Rezoning Transportation Analysis

Petition Number: 2019-089

Date	Description
08-21-2019	First Review

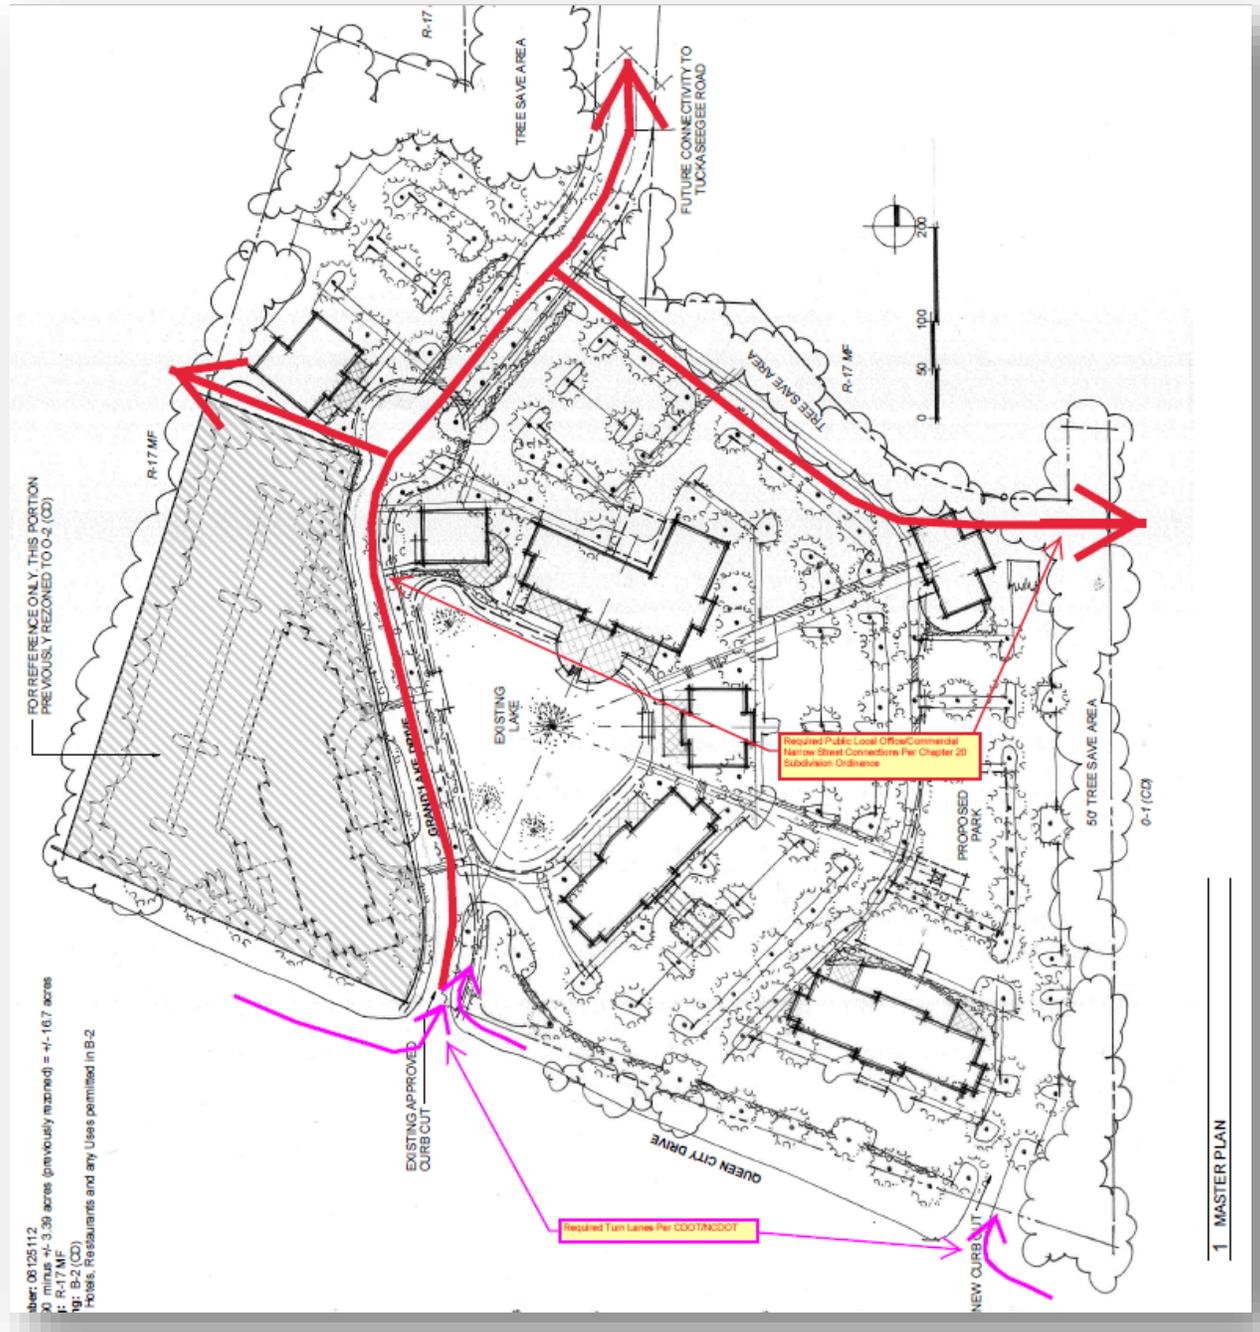
3. The petitioner should revise the site plan and conditional note(s) to commit to dedicate 36' right-of-way from Queen City Dr. Queen City Dr. is designated as an existing major collector street. The site plan should label and dimension the right-of-way from the road's centerline.

4. The petitioner should revise the site plan and conditional note(s) to commit and implement Queen City Dr. as a local collector street section (to accommodate 3-11' travel lanes), including an 8' planting strip and 6' sidewalk along the site's Queen City Dr. frontage.

5. The petitioner should revise the site plan and conditional note(s) to commit and implement a 150' NB Queens City Dr. left turn storage lane on with an appropriate bay taper at Queens City Dr.

6. The petitioner should revise the site plan and conditional note(s) to commit and implement a SB Grand Lake Dr. approach at Queens City Dr. to provide three (3) travel lanes (i.e.: 1-13' receiving lane, 1-11' right turn lane, and 1-11' left turn lane).

7. The petitioner should revise the site plan and conditional note(s) to commit, implement, and label Grand Lake Dr. within the development as a "public" local office/commercial narrow street section (see CLDSM U-04.16). Grand Lake Dr. needs to be constructed to the site's western property line per Chapter 20 of the City Subdivision Ordinance.

8. The petitioner should revise the site plan and conditional note(s) to commit, implement, and label two (2) street stubs connecting to Grand Lake Dr. One (1) "public" street stub to the south connecting to parcel ID 06125108, approximately where the existing Grand Lake Dr. cul-de-sac is located. One (1) "public" street stub to the north connecting Grand Lake Dr. to parcel ID 0612401, approximately at this parcel's northern property line (see exhibit below). Both public street stubs are required by Chapter 20 of the City's Subdivision Ordinance to be constructed to local office/commercial narrow street section standards (see CLDSM U-04.16).

9. The petitioner should revise the site plan to add a note specifying the existing Grand Lake Dr. driveway shall have a minimum 100' driveway stem before the first internal driveway.

10. The petitioner should revise the site plan to add a note specifying the proposed driveway located near the site's northern property line, shall be designated as a RI/RO driveway and constructed with a 100' raised median to restrict turning movements at this driveway. Grand Lake Dr. driveway shall have a minimum 50' driveway stem before the first internal driveway.
